Groundwater Application Review Summary Form

Application # G- 18886

PUBLIC INTEREST REVIEW FOR GROUNDWATER APPLICATIONS

TO: Water Rights Section Date 2/26/2020
 FROM: Groundwater Section Joe Kemper
 Reviewer's Name
 SUBJECT: Application G- 18886 Supersedes review of na
 Date of Review(s)

Theis Drawdown Estimates

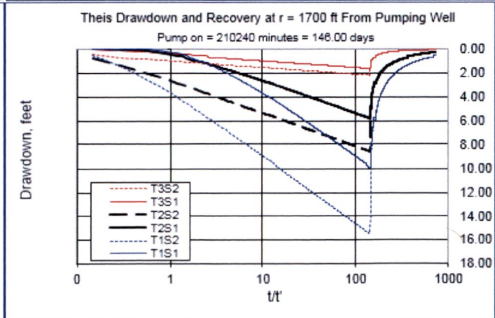
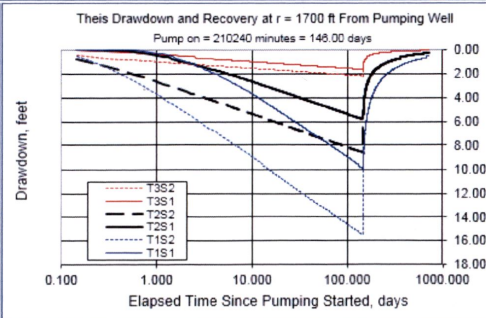
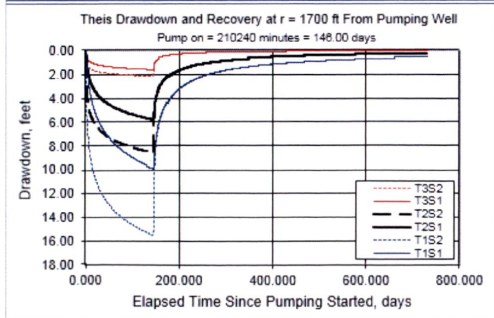
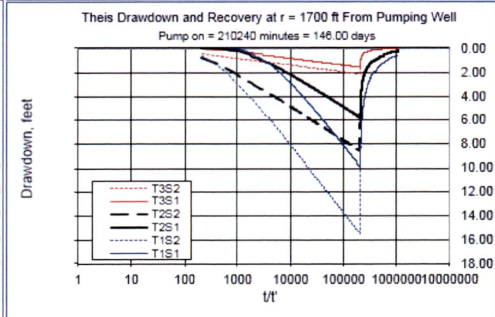
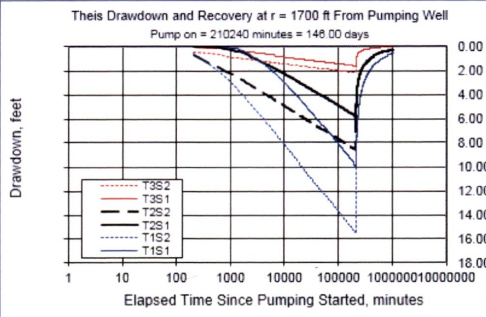
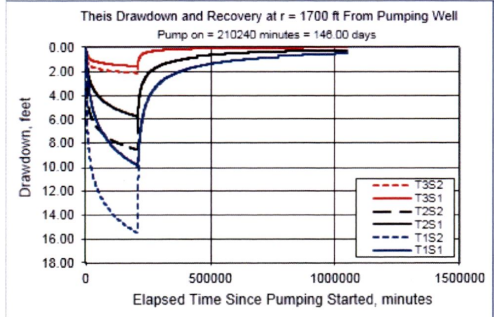
Input Data:	Var Name	Scenario 1	Scenario 2	Scenario 3	Units	
Total pumping time	t		146		d	
Radial distance from pumped well:	r		1700		ft	Q conversions
Pumping rate	Q		0.178		cfs	79.89 gpm
Hydraulic conductivity	K	5	10	50	ft/day	0.18 cfs
Aquifer thickness	b		100		ft	10.68 cfm
Storativity	S_1		0.001			15,379.20 cfd
	S_2		0.0001			0.35 af/d
Transmissivity Conversions	T_ft2pd	500		1000	ft2/day	
	T_ft2pm	0.3472222	0.6944444	3.4722222	ft2/min	
	T_gpdpt	3740	7480	37400	gpd/ft

Stream Depletion Model Results

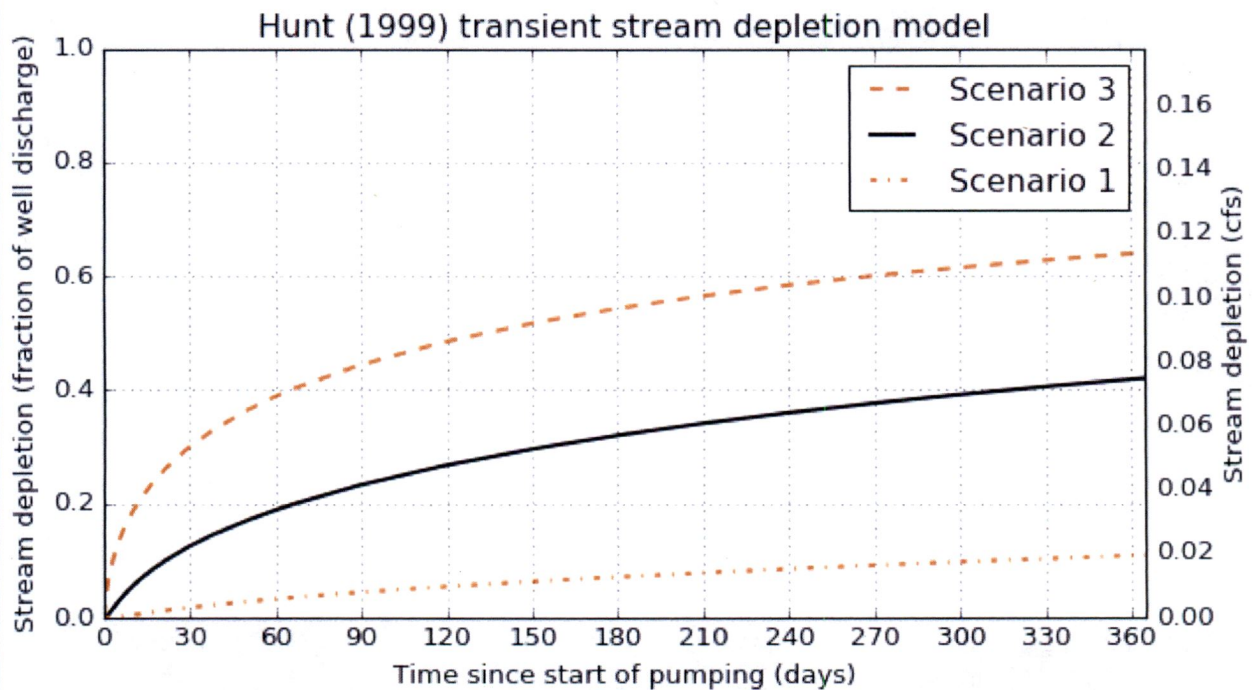
Stream depletion for Scenario 2:

Days	10	30	60	90	120	150	180	210	240	270	300	330	360
Depletion (%)	6	13	19	23	27	30	32	34	36	38	39	41	42
Depletion (cfs)	0.01	0.02	0.03	0.04	0.05	0.05	0.06	0.06	0.06	0.07	0.07	0.07	0.07
